REF NO.	AT04050
DATE	Mar. 26, 2004
$(\mathbf{C})$	Page 1 of 2

- **SUBJECT:** IMPROVED SEAL FOR ENGINE CYLINDER HEAD COVER ON SAA6D114E-2
- **PURPOSE:** To introduce an improved engine cylinder head cover seal for the SAA6D114E-2 engines

3. Details of the improvement

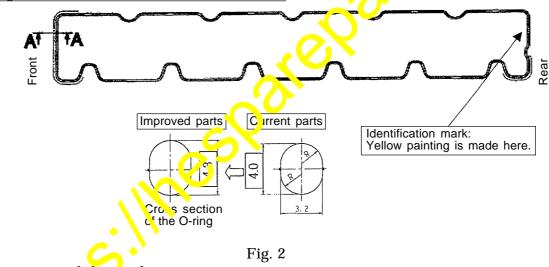
(1) Improvement of the seal (O-ring) In order to increase the bearing factor at the front and that ends, the thickness of the O-rings used at the ends has been increased.

(2) Improvement of the washer In order to increase the overall bearing factor, <u>the thickness of the cover mounting</u> <u>washers</u> as been increased.
